**RE: Alameda Development
6100 Alameda NE
Conceptual Grading and Drainage Plan
Engineer's Stamp Date: 12/06/18
Hydrology File: C18D086**

**Drainage Report
For**

**RE: Alameda Development
6100 Alameda NE
Conceptual Grading and Drainage Plan
Engineer's Stamp Date: 09/12/18
Hydrology File: C18D086**

Conceptual
Grading Plan
date:
12-6-18
sheet:
3

CHECK FALL OF WEST OUTLET

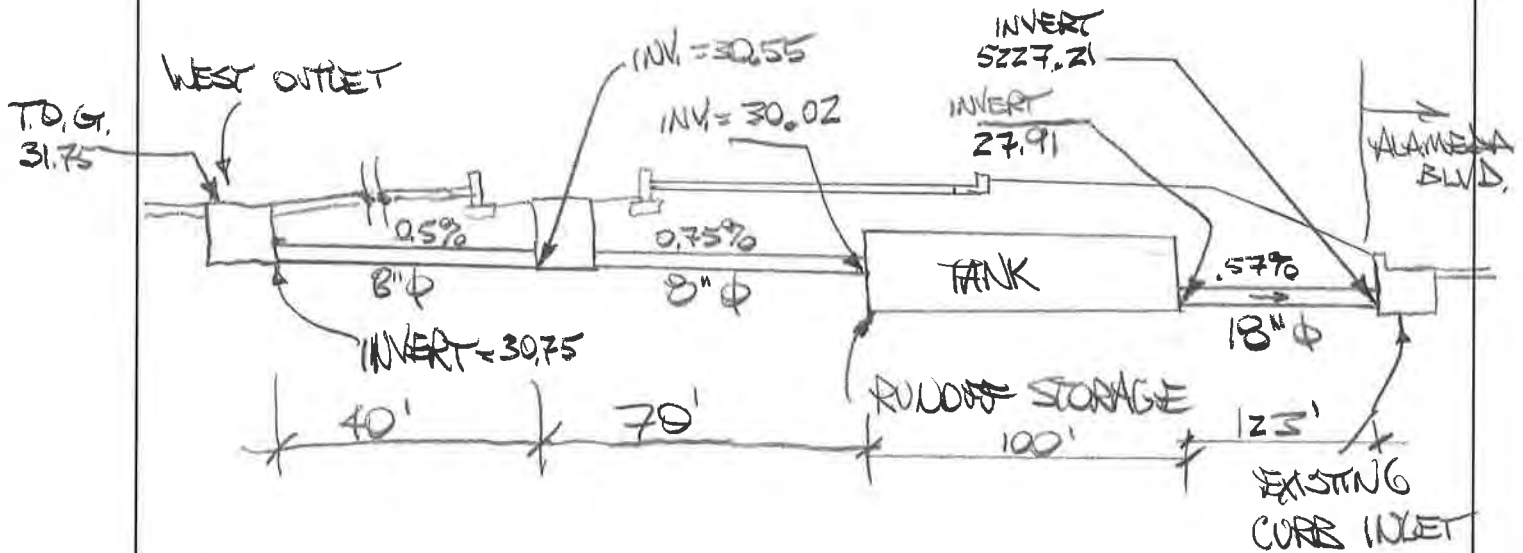
12. Drainage Report. Please provide the maintenance responsibilities for each detention and/or first flush ponds.
13. Drainage Report. It appears that the storm drain system and inlet near the drive entrance to San Pedro Blvd is too low to drain through the underground system and then into the existing storm sewer on Alameda. Please provide the Hydraulic Grade Line in a profile from the existing storm drain truck line in Alameda through the underground system to the sump inlet near the drive entrance to San Pedro Blvd in a profile view.

13. A diagram has been added to the drainage report to describe the profile of the runoff path from the storm inlet at the San Pedro drive entrance to the outlet in Alameda Blvd.

BASIN III HYDROGRAPH

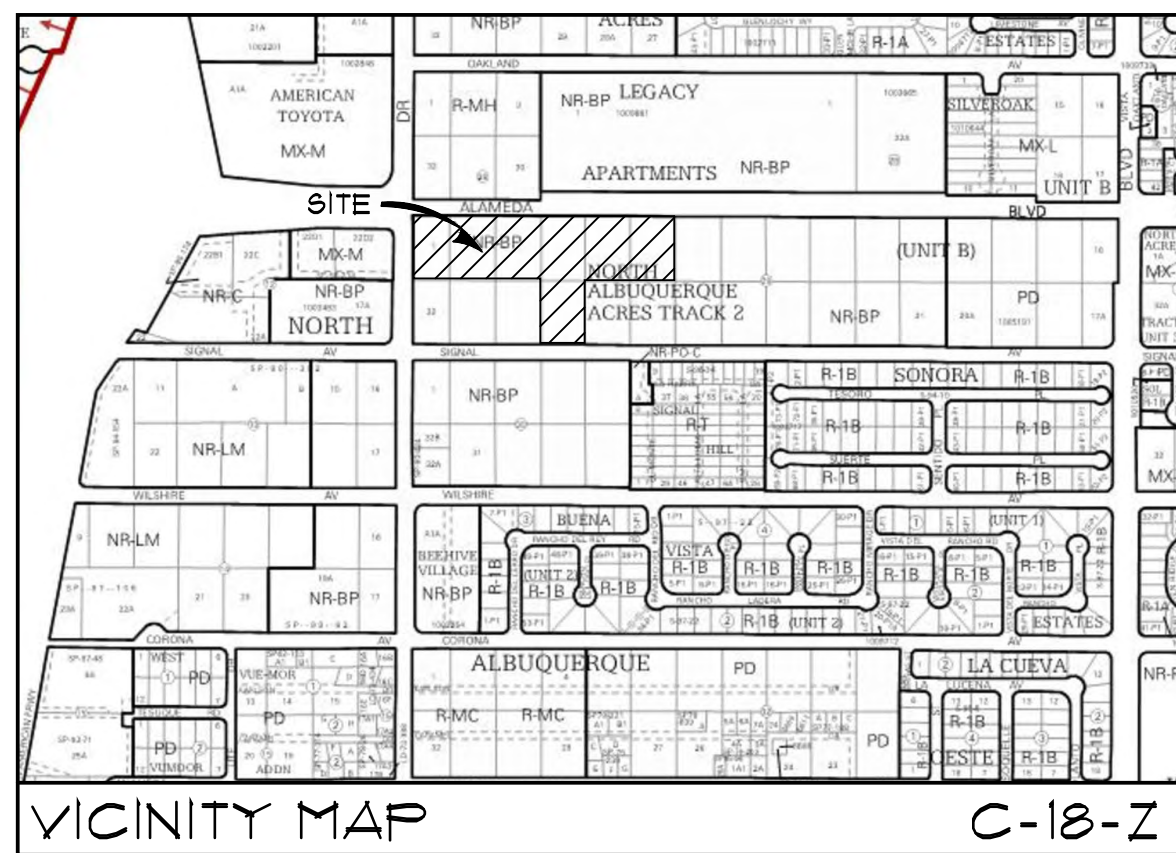
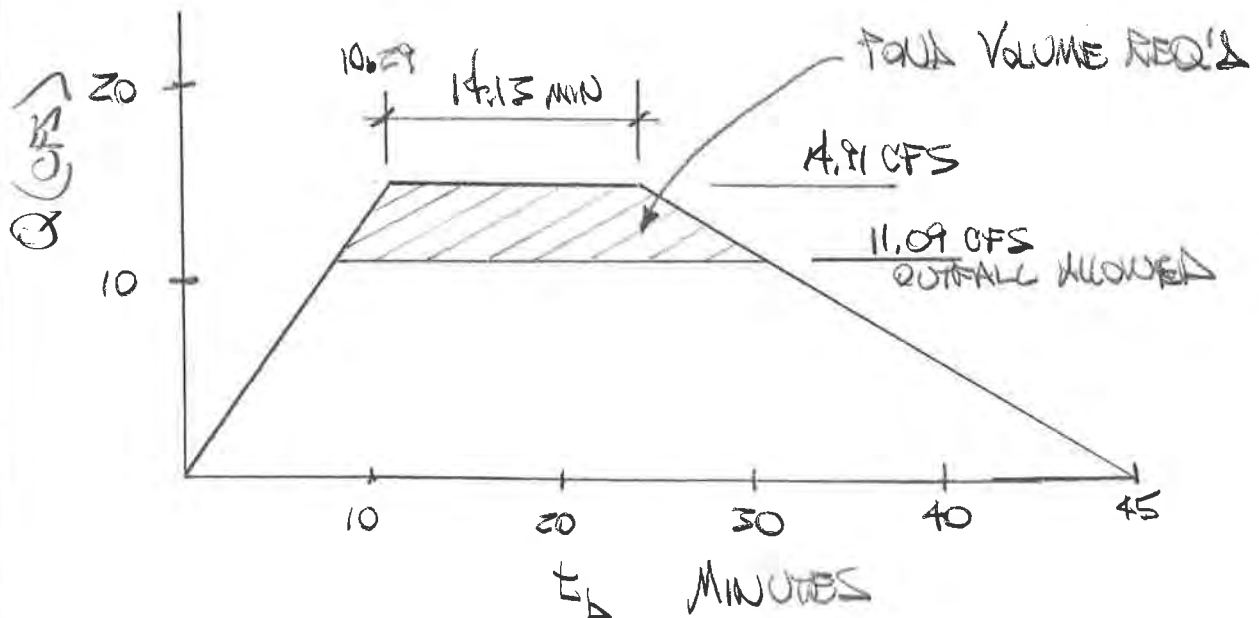
11. Drainage Report. Based on some preliminary calculations, it appears that the proposed underground detention system will be too small. Please reevaluate the underground system based on the calculations from item #10.

11. The underground detention system in Basin III has been enlarged to appropriately handle the expected peak runoff volume.
12. A note has been added to the plan to define responsibilities for maintenance of the onsite drainage facilities.

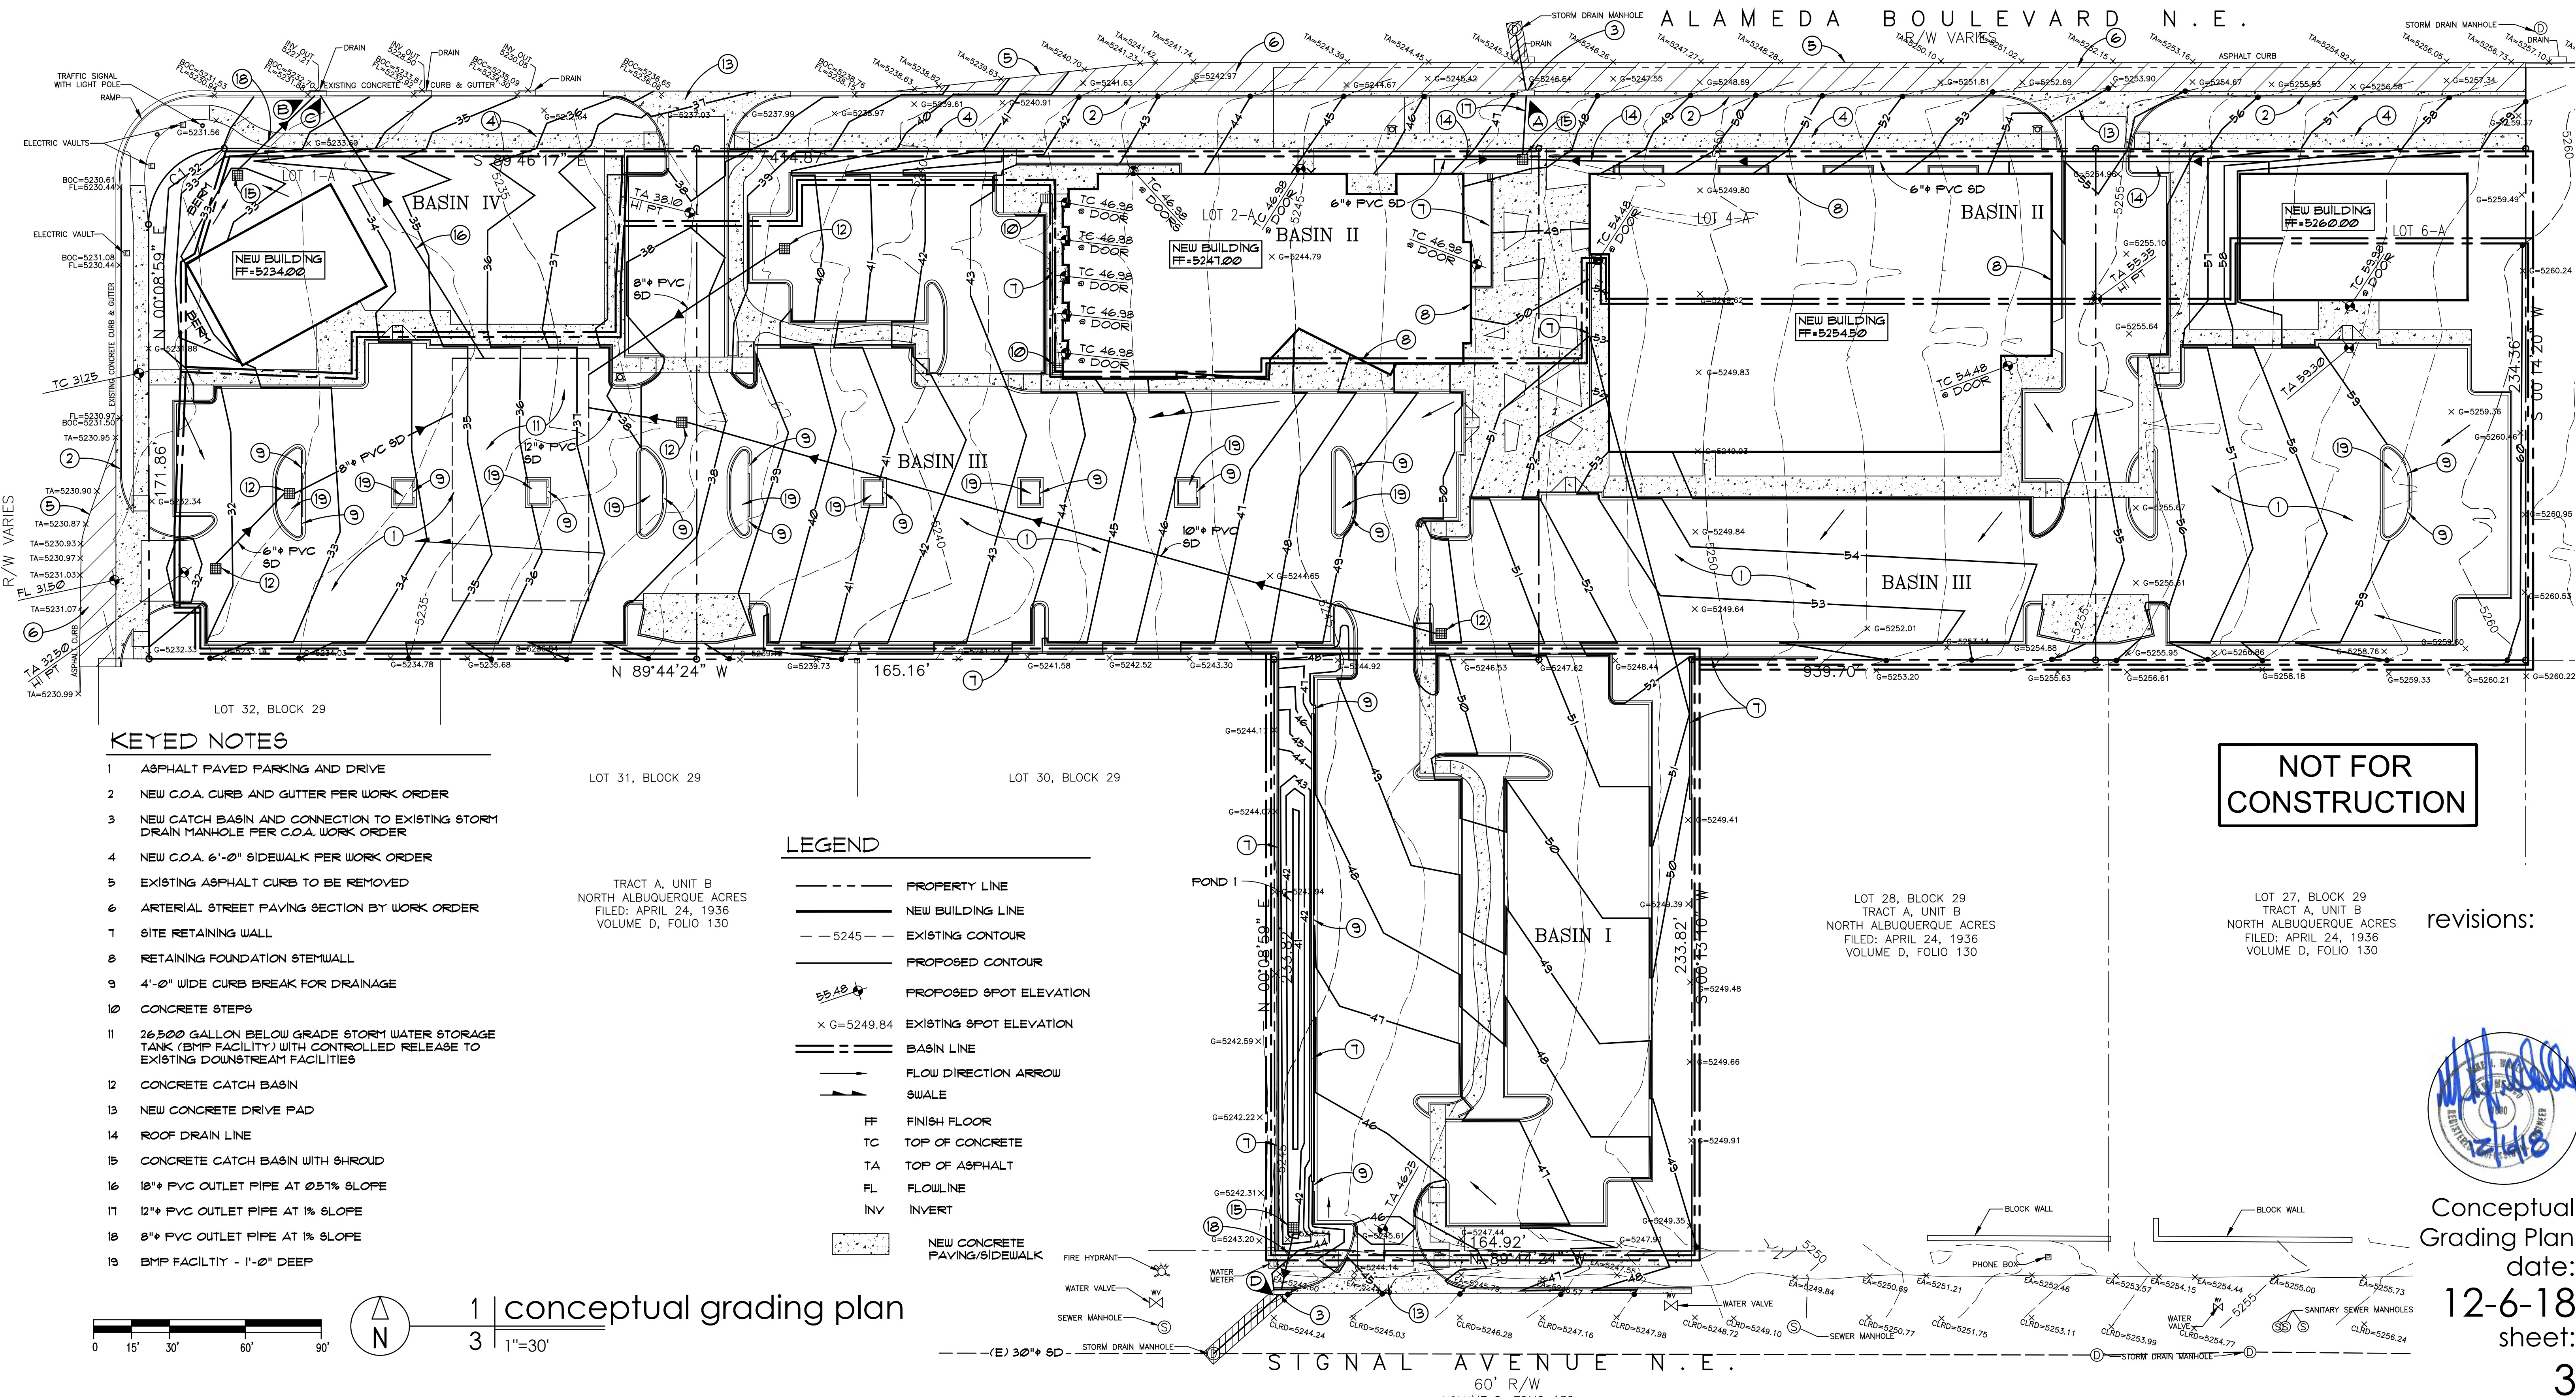
1. Sheet 3. Basin II is missing the northern boundary line along, please add this.
2. Sheet 3. Please reevaluate Basin II's area. It appears that a portion of the building on Lot 2-A and drive entrance should be included in Basin III which discharges into the underground system.
3. Sheet 3. Please add a water block at the entrances to Alameda Blvd and Signal to ensure that drainage does not leave the site.
4. Sheet 3. Please add an inlet within the drive entrances along Alameda to capture the runoff and direct it to Drainage Point "A".
5. Sheet 3. Please add a berm or add a grade line to redirect the runoff to the proposed inlet in Basin IV. The grading as is appears to allow runoff into San Pedro.
6. Sheet 3. Please call out the storm pipe size.
7. Sheet 3. Please show and label the volume provided for the

1. The north boundary line for Basin II has been added to the plan.
2. The area for Basin II has been revised and the change is reflected in the runoff calculations submitted in our Drainage Report.

3. Water block changes have been made at the San Pedro, Signal and Alameda drive entrances to the site.
4. This comment was eliminated per our email/telephone conversation.

5. A landscape berm has been added to prevent runoff from exiting the site into San Pedro Blvd.
6. Storm drain line sizes have been added to the plan.
7. The storm water quality volumes and BMP facilities have been identified in the calculations and on the plan.
